AGENDA
PLANNING COMMISSION
116 WEST NEEDLES
BIXBY, OKLAHOMA
April 18, 2013 6:00 PM

STAFF REPORT

To: Bixby Planning Commission
From: Erik Enyart, AICP, City Planner *EE*
Date: Friday, April 12, 2013
RE: Report and Recommendations for:
PUD # 47-C – Woodcreek Office Park – Sack & Associates, Inc.

City of Bixby, Tulsa County, Oklahoma
Planned Unit Development Number 47-C
March 2013

Sight Plan Exhibit
SAI 4.10.13

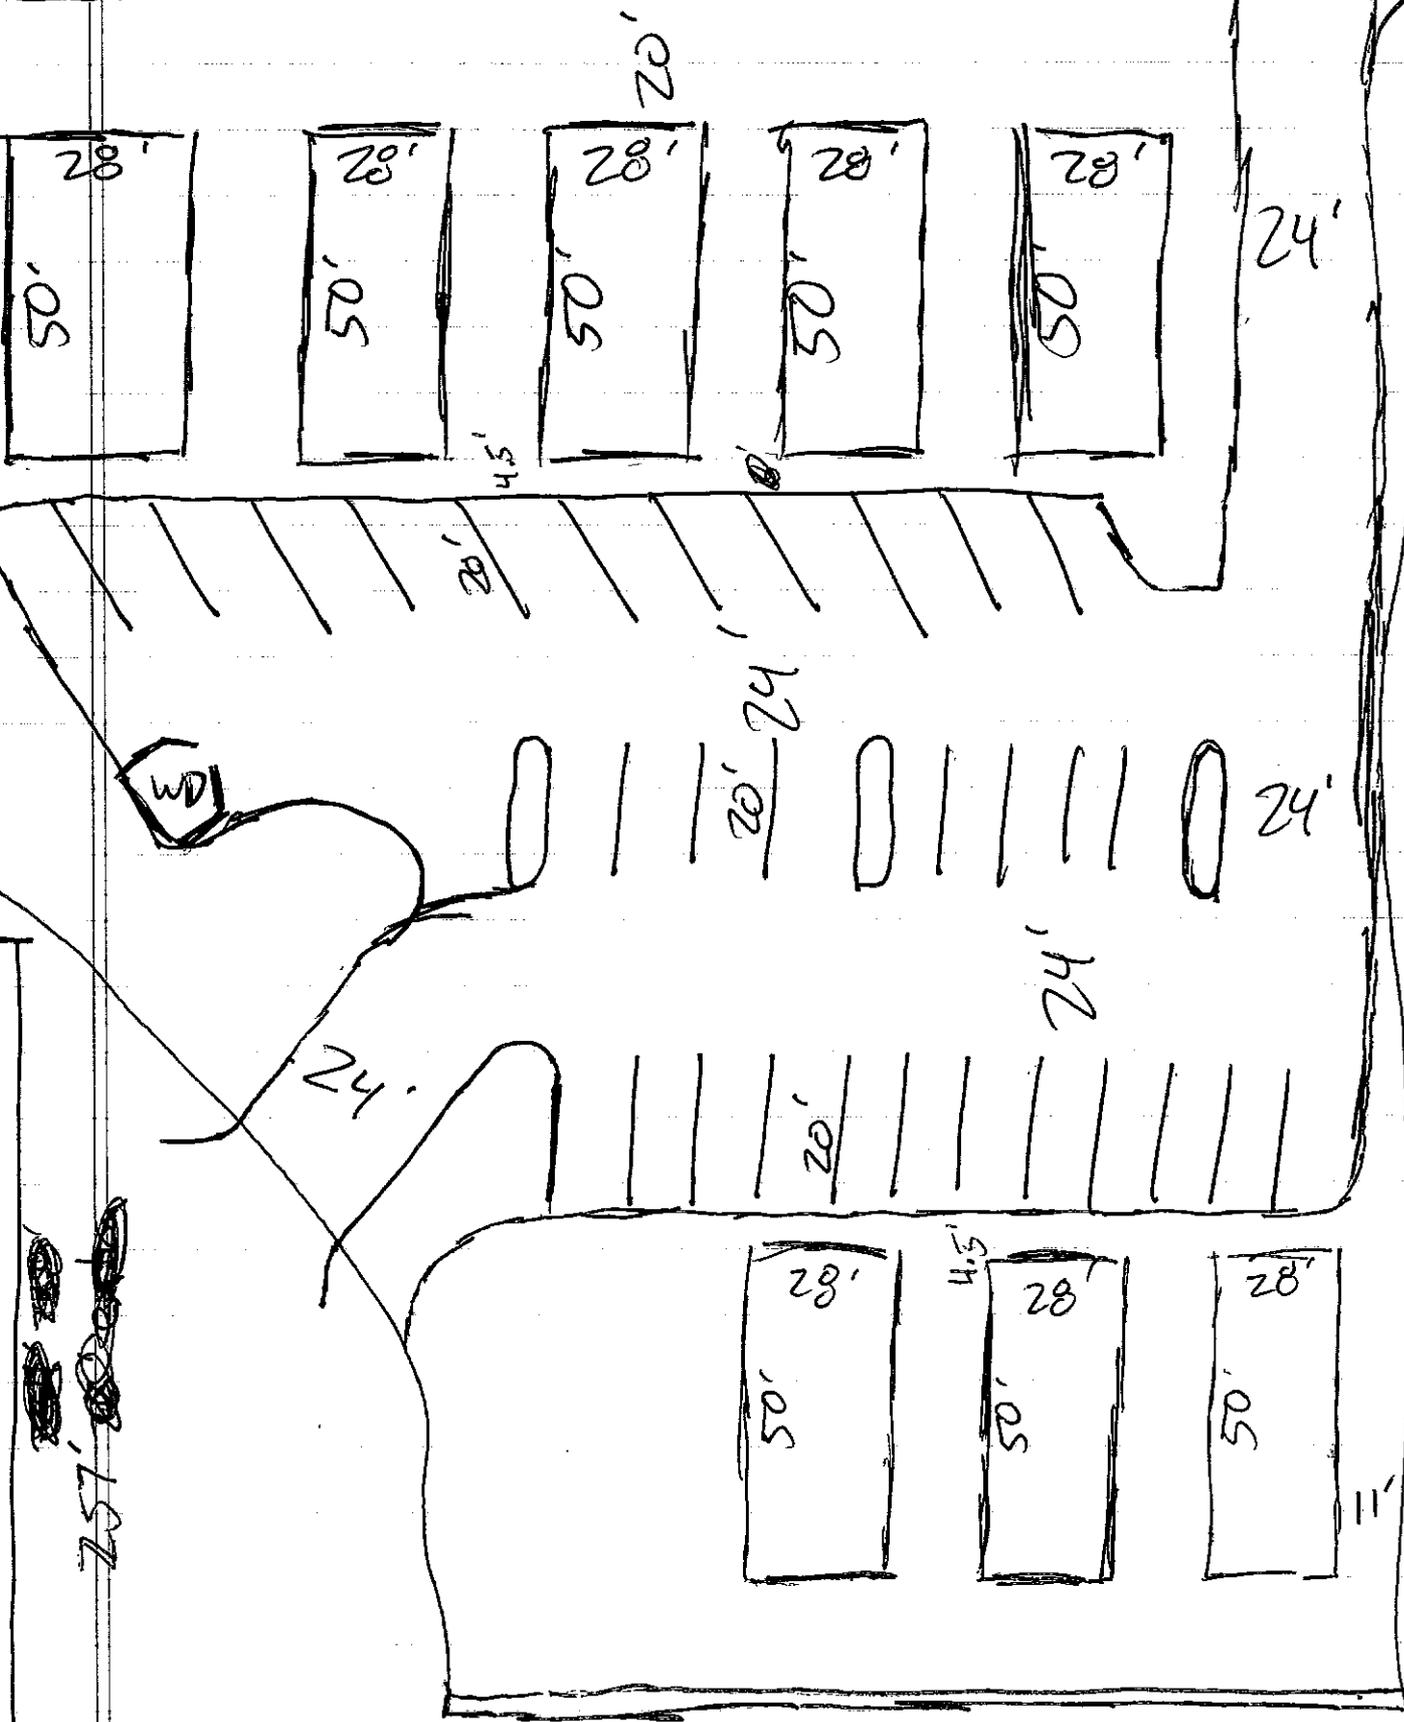
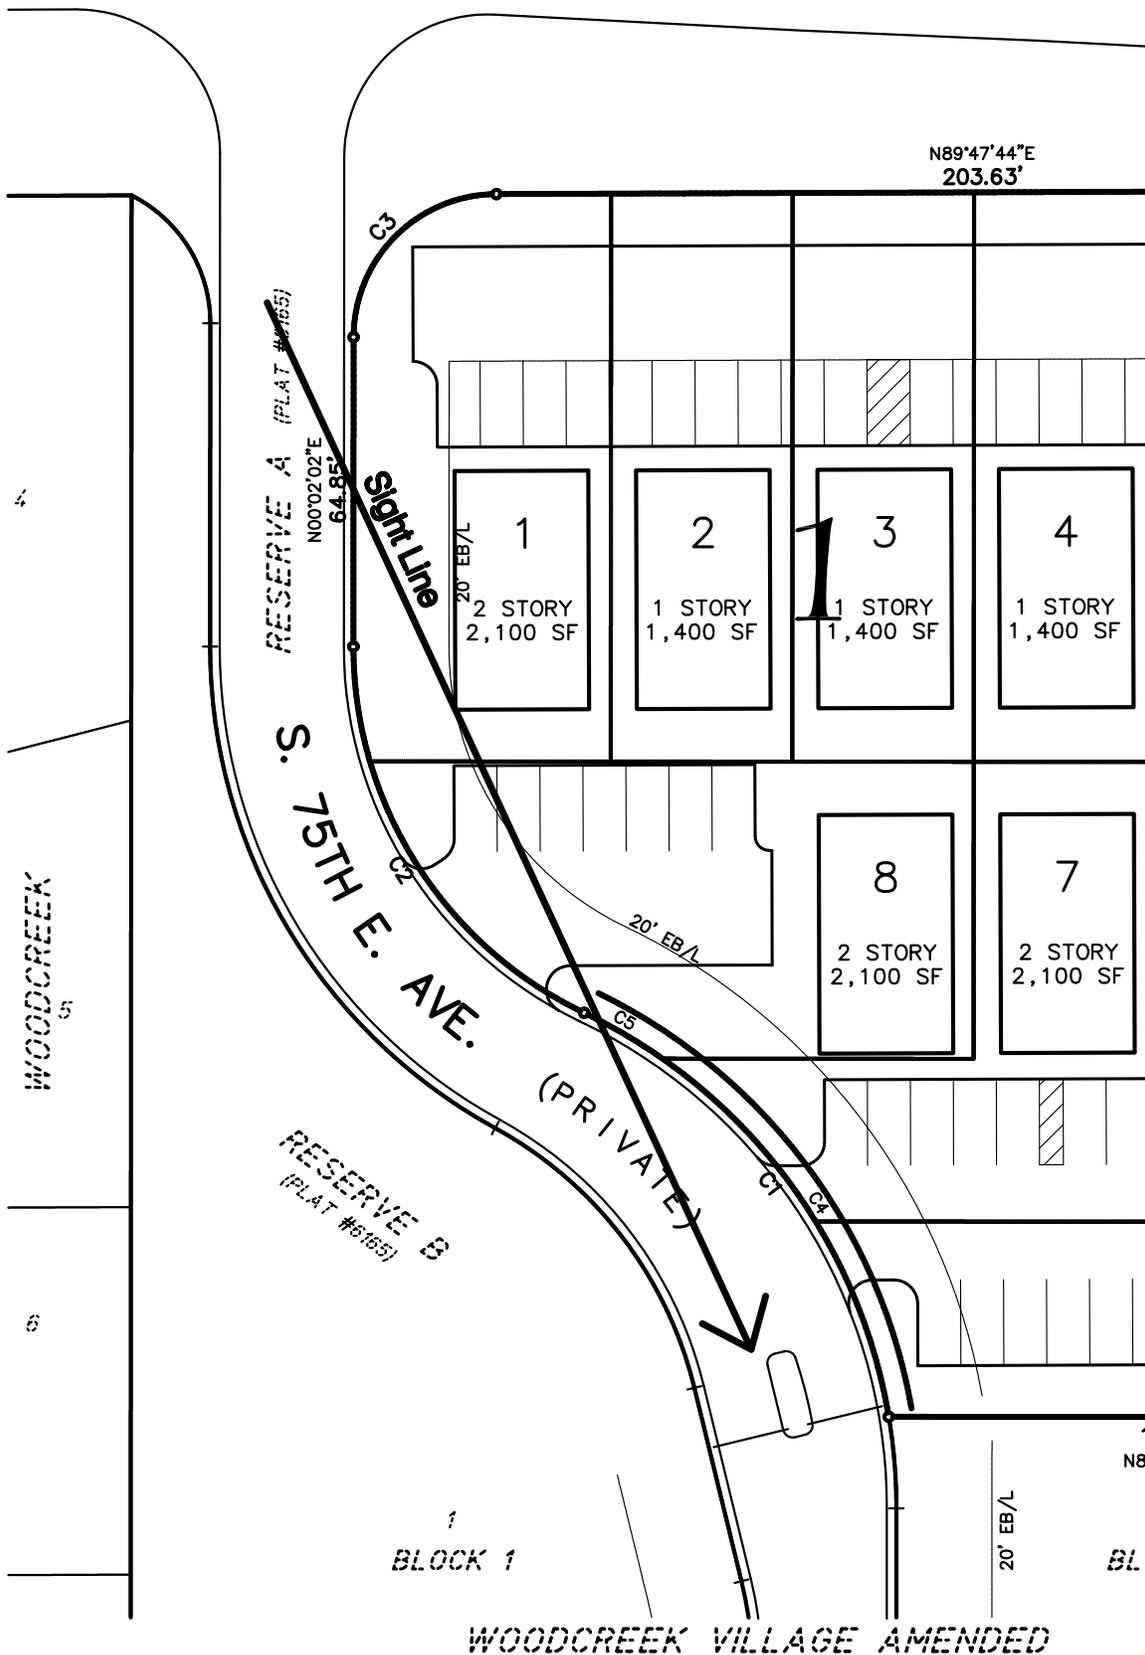
2&15. In regards to the traffic visibility and the bend in 75th Street, we believe that there is adequate distance for a driver to see as indicated on the attached sketch. We are proposing to change the setback to 20' as part of this Major Amendment. This road has a very low traffic flow and the gate and curve natural slow the traffic down. The remainder of Woodcreek Village Amended front building setback is also 20'. Therefore, we request that the building setback part of the amendment stay intact.

SITE PLAN

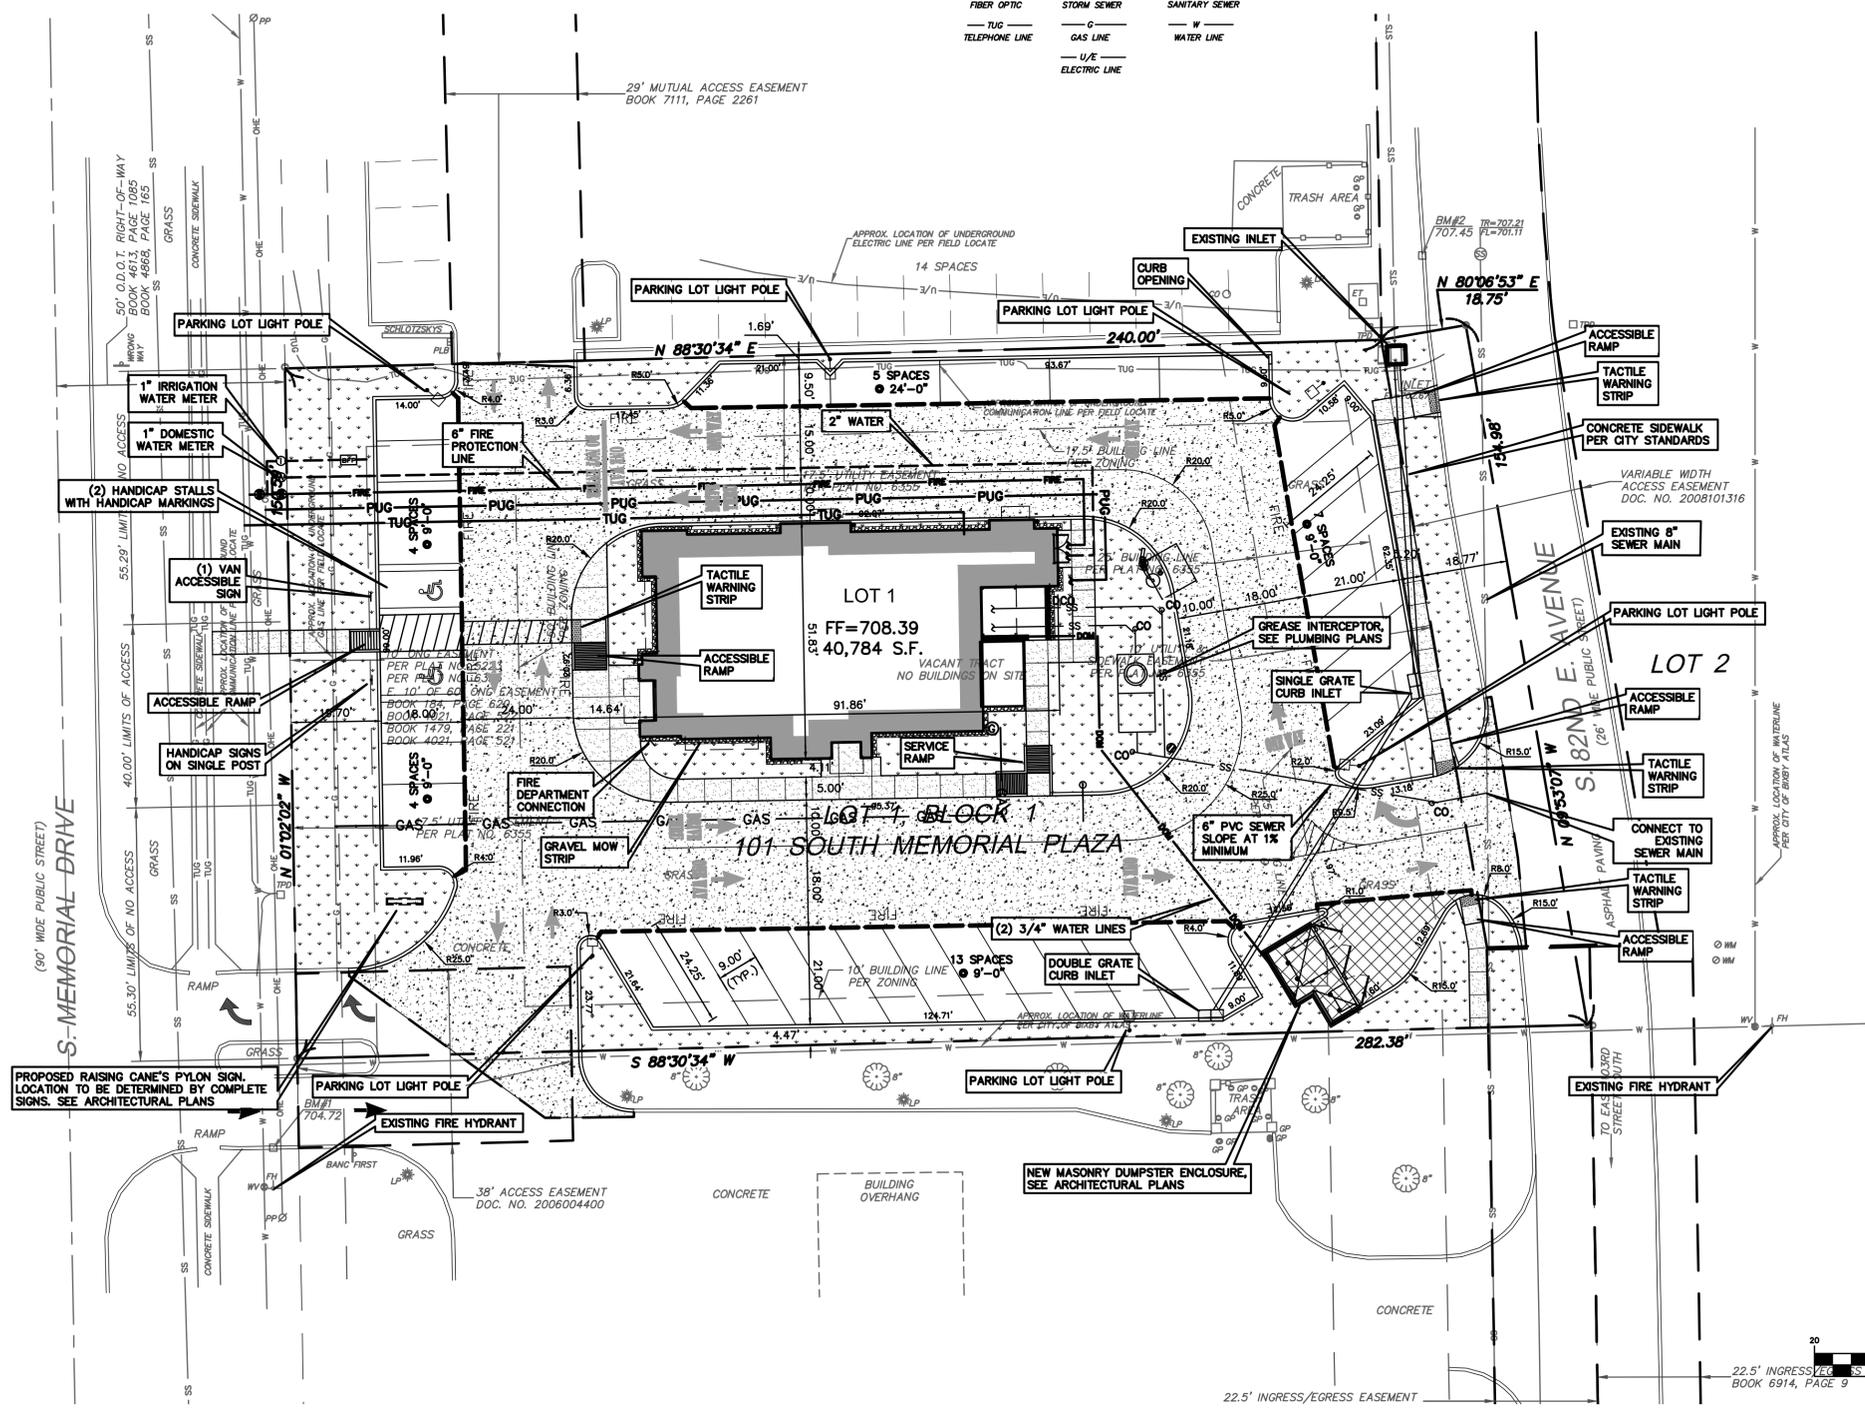
3. The proposed driveways and their curb return radii must comply with applicable standards and City Engineer and/or Fire Marshal requirements.
4. A note placed on the building polygon reports "40,784 square feet," which appears to be a reference to the total site area, not the building itself. To avoid confusion, this should be replaced with the correct 3,613 square foot number, if the label remains in its present location. Appears also on Landscape Plan drawing L1.01.

10. The regular and van-accessible handicapped-accessible parking spaces and access aisles are dimensioned, but do not indicate compliance with the space width or striping standards Zoning Code Section 11-10-4.C Figure 3. These design items need to be corrected. The Applicant should make use of a handicapped-accessible parking
